Subject: River Bend Station  
Docket No. 50-548  
License No. NPF-47  
License Amendment Request (LAR) 2000-24 Rev. 1, Operational  
Conditions For Handling Irradiated Fuel in the Primary Containment.

**ATTACHMENT 2**  
**TO**  
**LETTER NO. RBG-45757**  
**PROPOSED TECHNICAL SPECIFICATION**  
**AND**  
**RESPECTIVE SAFETY ANALYSES**  
**IN THE MATTER OF AMENDING**  
**LICENSE NO. NPF-47**  
**ENERGY OPERATIONS, INC.**  
**DOCKET NO. 50-458**

**PROPOSED TECHNICAL SPECIFICATION MARK-UPS**

**THAT CAN BE VIEWED AT  
THE RECORD TITLED:  
DWG. NO. EM-1A-4  
STATION ARRANGEMENT  
UNIT 1 CONSTRUCTION  
WITHIN THIS PACKAGE...OR,  
BY SEARCHING USING THE  
DOCUMENT/REPORT  
DWG. NO. EM-1A-4**

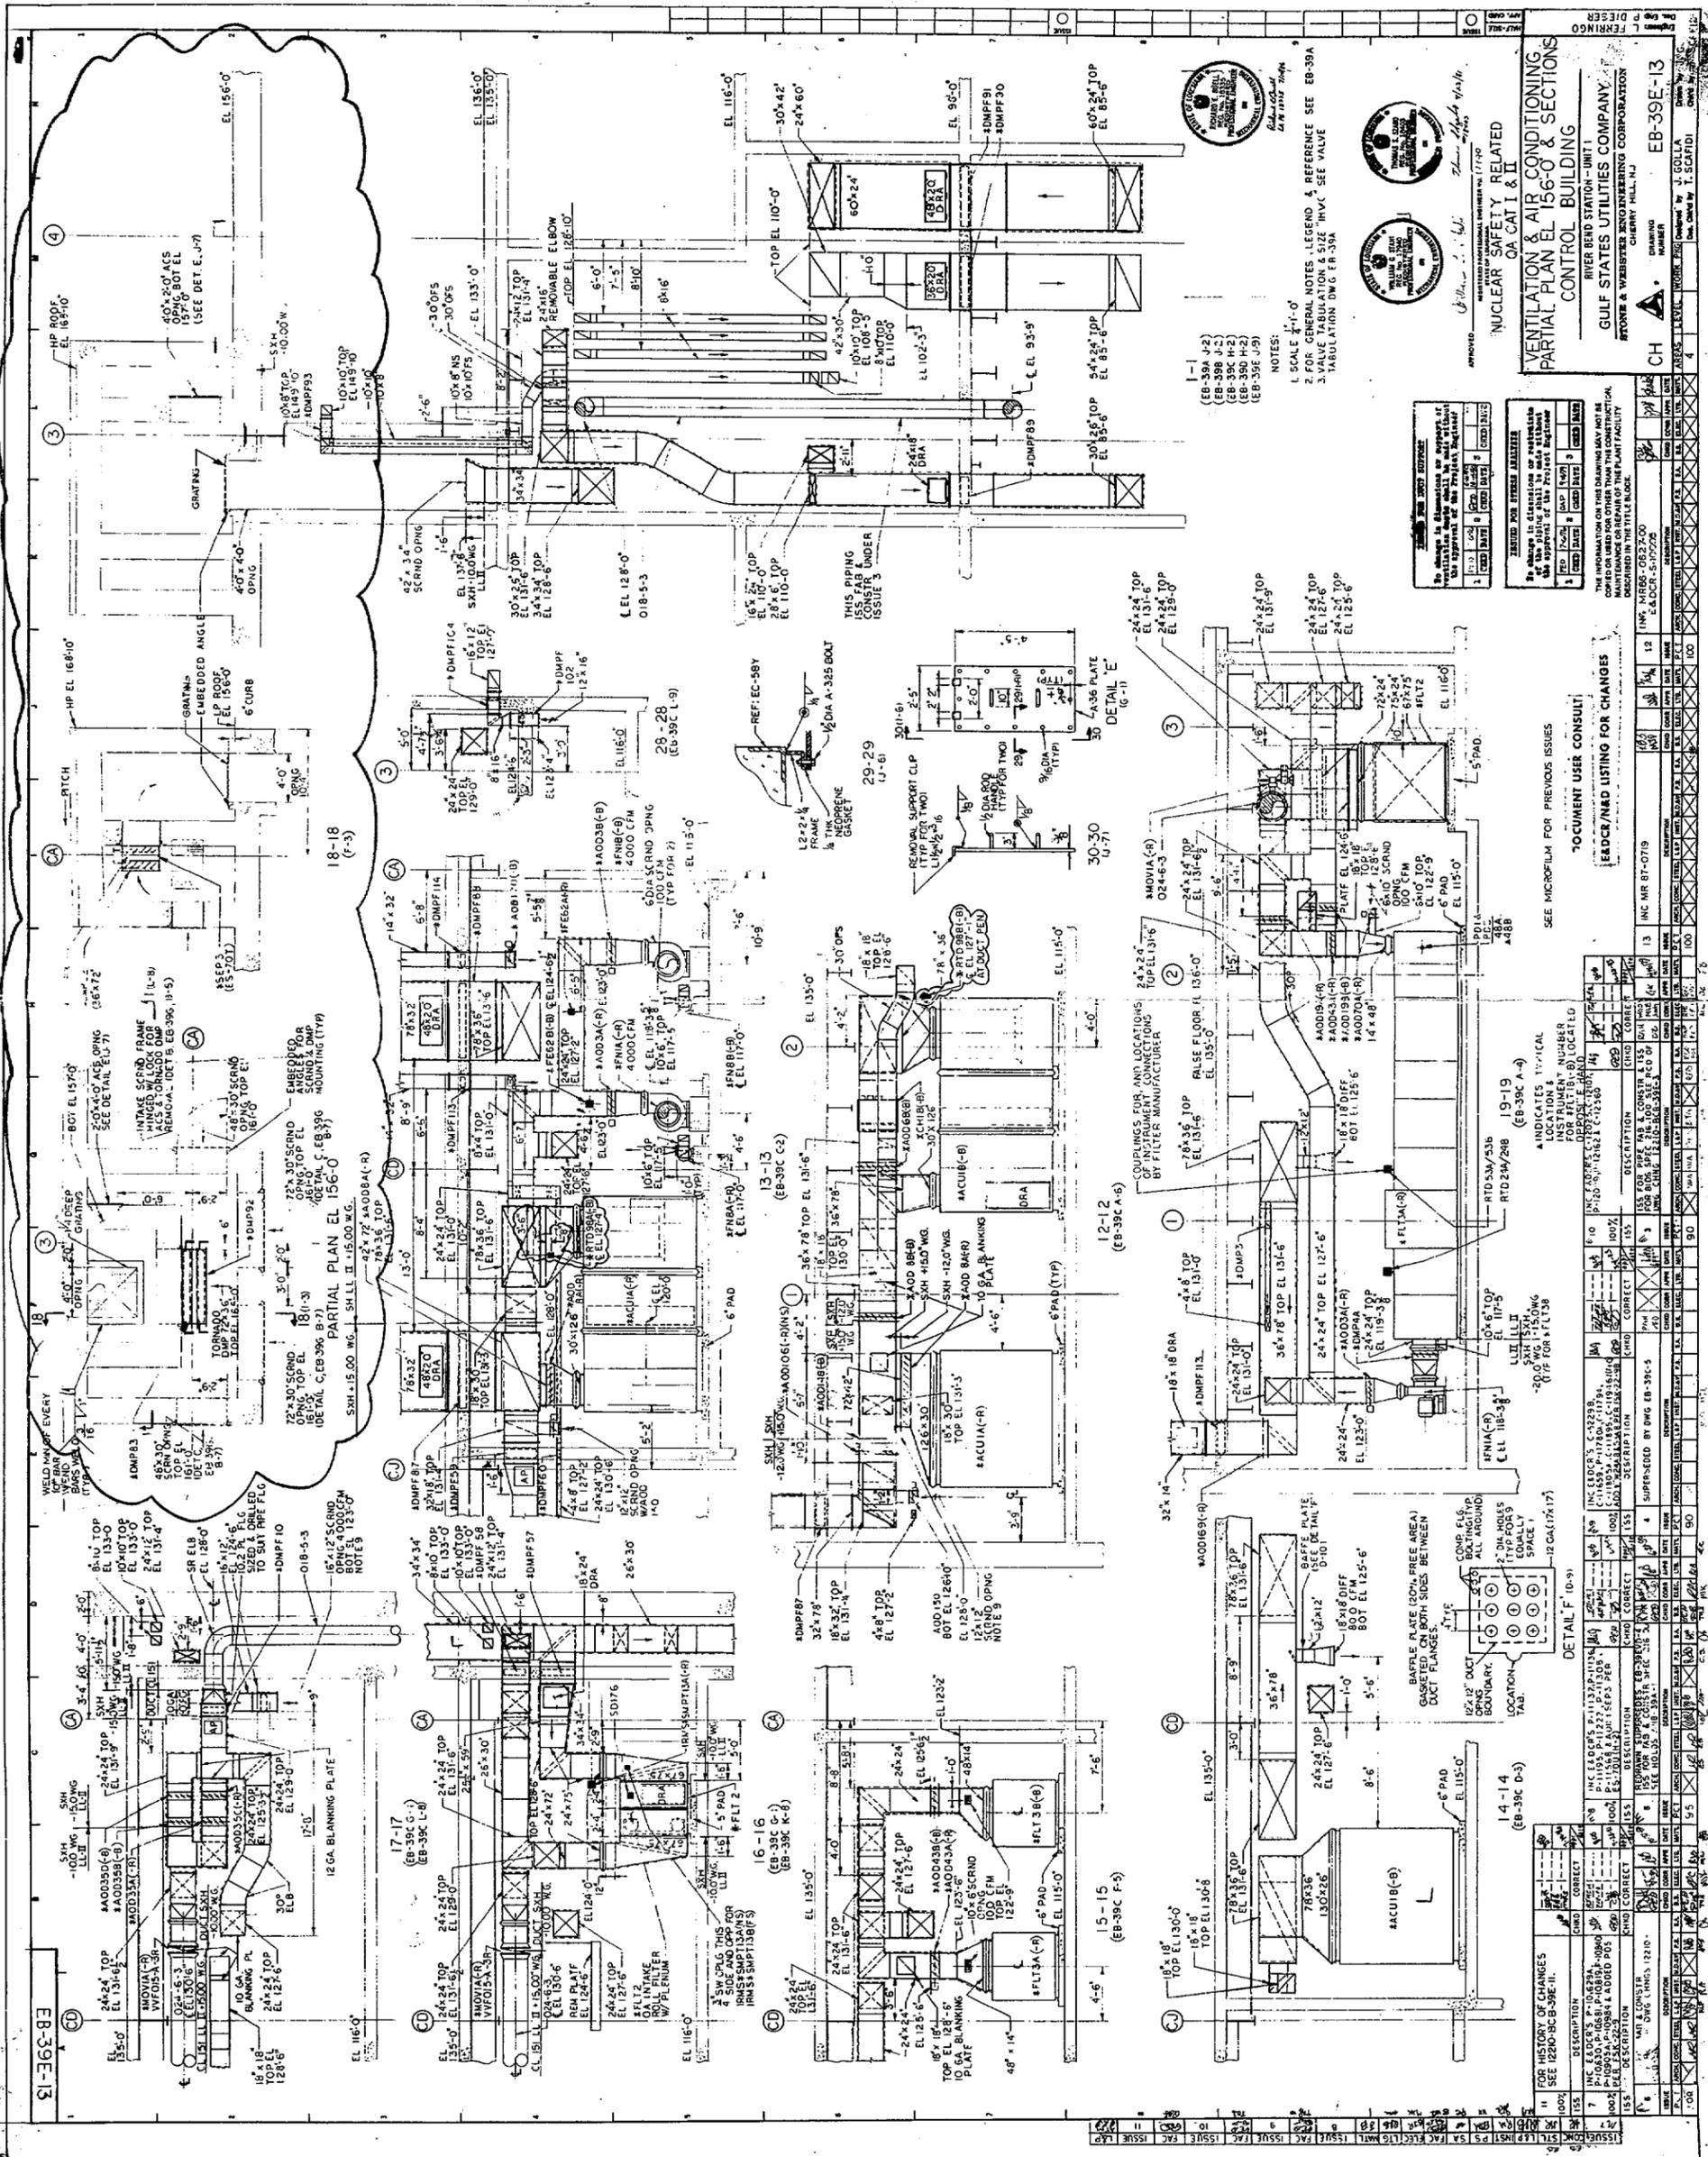
The locations for the main control room air intakes and other points of interest are marked on enclosed drawing number EM-001A. The locations of the intakes were derived from drawings EB-039D and EB-029E which are also enclosed with the areas of interest highlighted. The approximate coordinates for the key locations have been added for convenience. The release locations are not marked since release location is assumed to be at the reactor building perimeter.
